7085 GOREWAY DRIVE DEVELOPMENT

FLOOD HAZARD ASSESSMENT

PROJECT 18-528

Last Revised March 14, 2023

DESIGNED BY: S.S.	SCALES:	PROJECT No. 18-528
CHECKED BY: E.G.	HORIZONTAL: 1:1000	DRAWING No. FPM
DRAWN BY: J.N.	VERTICAL: N/A	SHEET No. 01
DATE: JULY 20, 2018

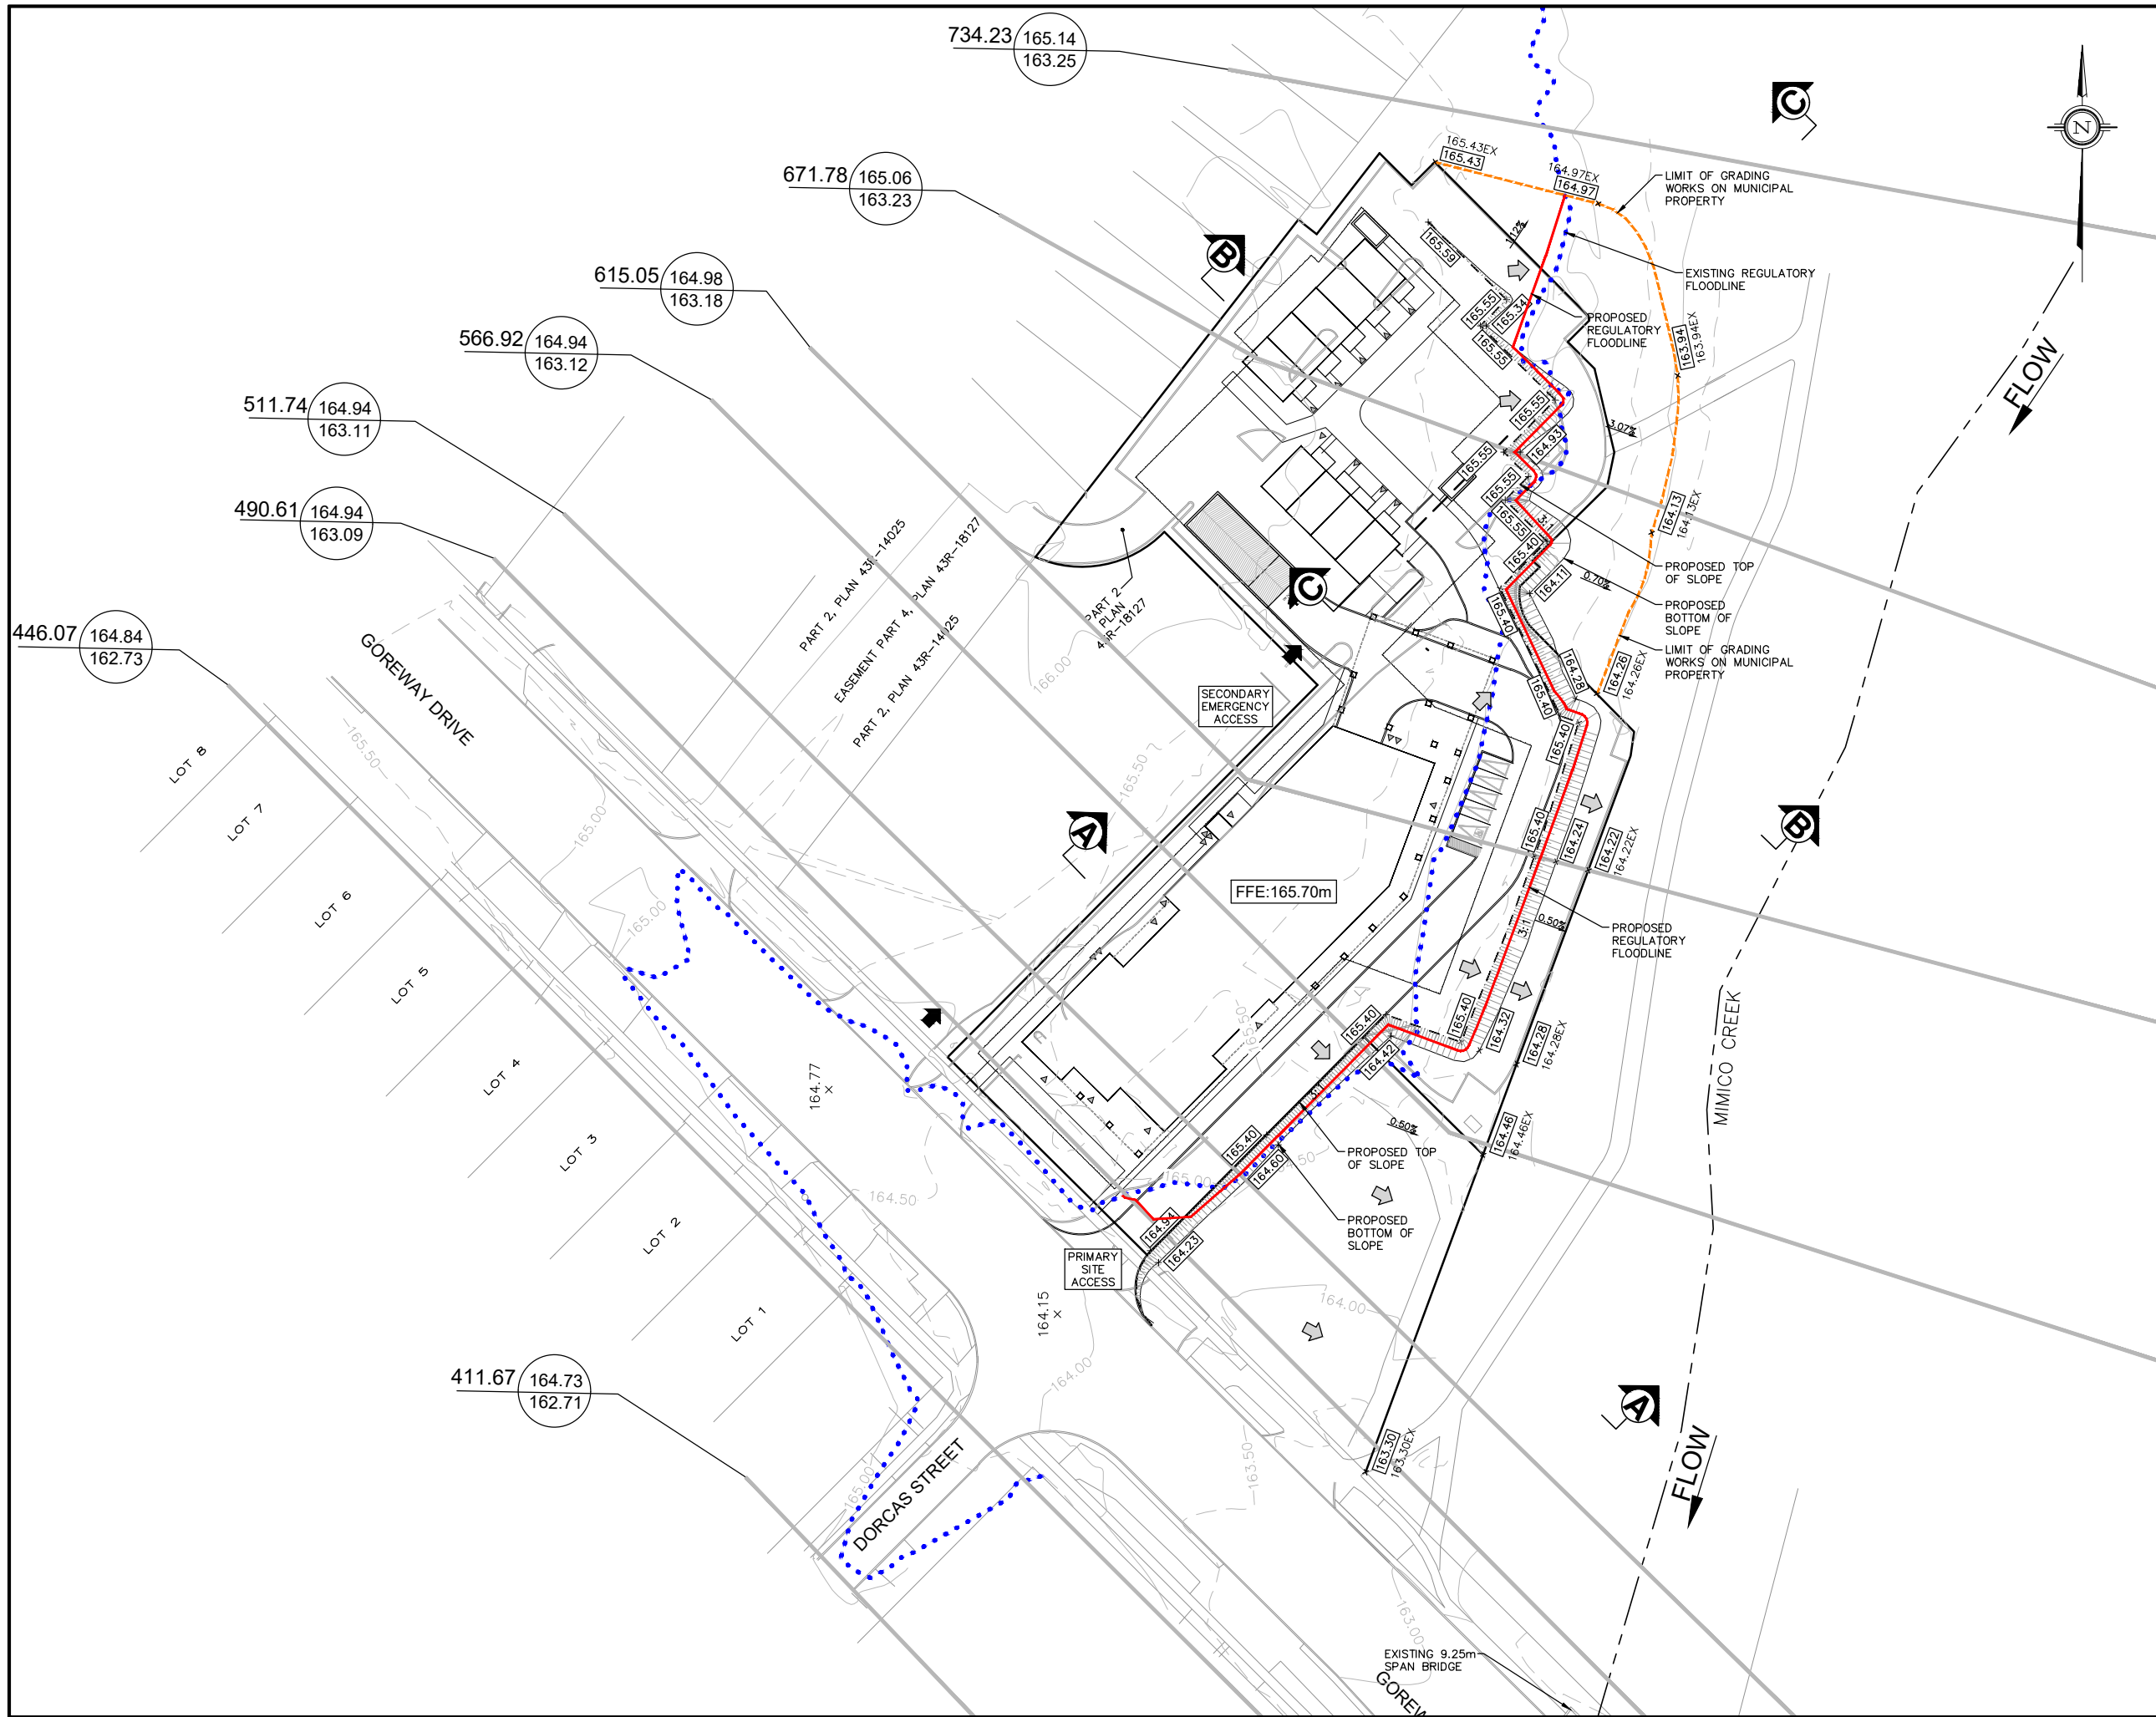
3.	<p>TRCA Existing Regulatory Floodplain mapping shows that a section of the neighbouring property (7085 Goreway Drive) is outside of the flood plain, however, Sheet No 1 shows that under proposed condition the entire 7085 Goreway Drive will be under Regulatory Floodlines. This is not acceptable. Please revise the grading plan so that the existing flooding risk on the adjacent property is maintained.</p> <p>It should be recognized that TRCA mapping had to be updated to more accurately reflect existing conditions. As per the report, a detailed survey was completed and the Goreway bridge structure was recoded. This resulted in the flood risk you noted. Not proposed conditions.</p>

4.	<p>Sheet No 1 shows that grading will be undertaken on the northwest section of the neighbouring property (7085 Goreway Drive). Please note that the applicant should acquire permission from the owner of 7085 Goreway Drive and provide a record as part of future applications.</p> <p>Agreed. The City has already provided verbal approval of the proposed grading works, a record will be provided as part of future applications.</p>

3. TRCA Existing Regulatory Floodplain mapping shows that a section of the neighbouring property (7085 Goreway Drive) is outside of the flood plain, however, Sheet No 1 shows that under proposed condition the entire 7085 Goreway Drive will be under Regulatory Floodlines. This is not acceptable. Please revise the grading plan so that the existing flooding risk on the adjacent property is maintained.

4. Sheet No 1 shows that grading will be undertaken on the northwest section of the neighbouring property (7085 Goreway Drive). Please note that the applicant should acquire permission from the owner of 7085 Goreway Drive and provide a record as part of future applications.
